Date: 17 September 2024
Your Ref: DC/23/0306
Our Ref : NA/3983/2024_002_r0
Email: natasha@herringtonconsulting.co.uk

Further information related to the discharge of condition 3 for the proposed development at Sluetts Farm Buildings, Two Mile Ash, Horsham, West Sussex

PROJECT: SLUETTS FARM, HORSHAM

Figure 1 – Site boundary (red) and area to be drained (yellow).

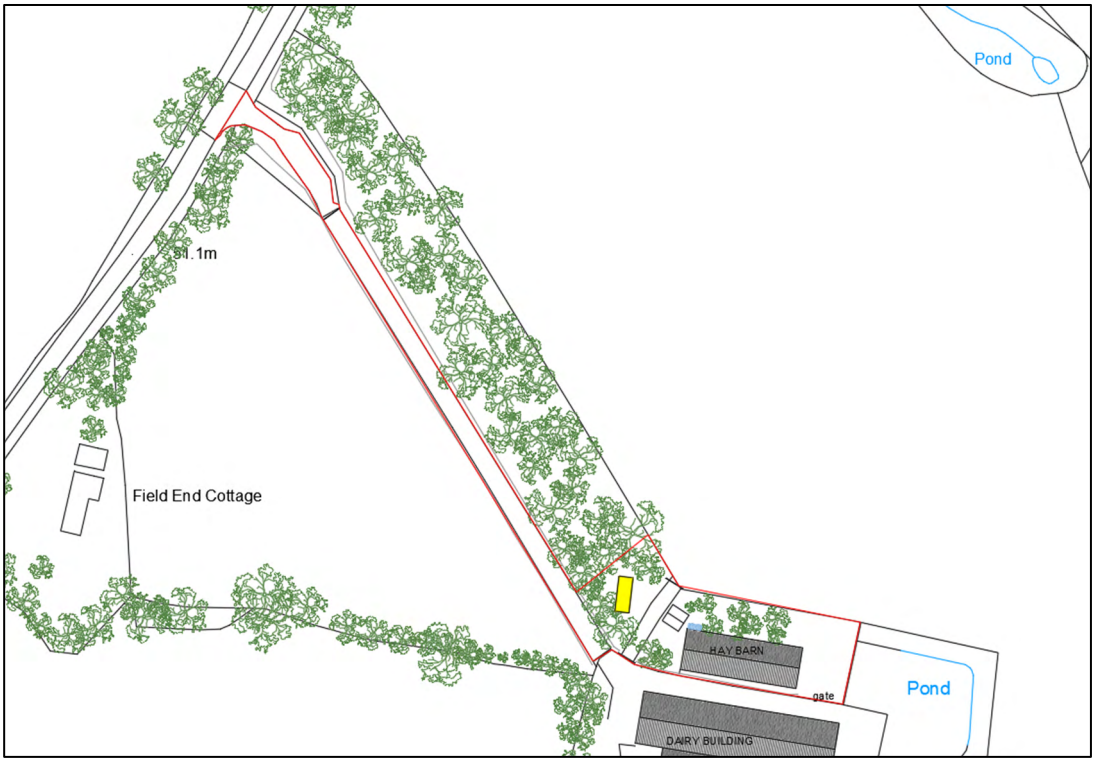
- Measurement of the total site area, with supporting catchment plans and calculations is required to support Table 2 of the Discharge of Conditions Letter which states that 38m2 is to drain to the geo-cellular storage tank, it is noted that this includes a 10% allowance for urban creep.

The total site area is approximately 2560m^2. A catchment plan delineating the proposed areas to be drained are shown in yellow in Figure 1. The area of the proposed dwelling is approximately 34m^2. When a 10% allowance is applied for urban creep, the area to be drained has been rounded up to 38m^2.
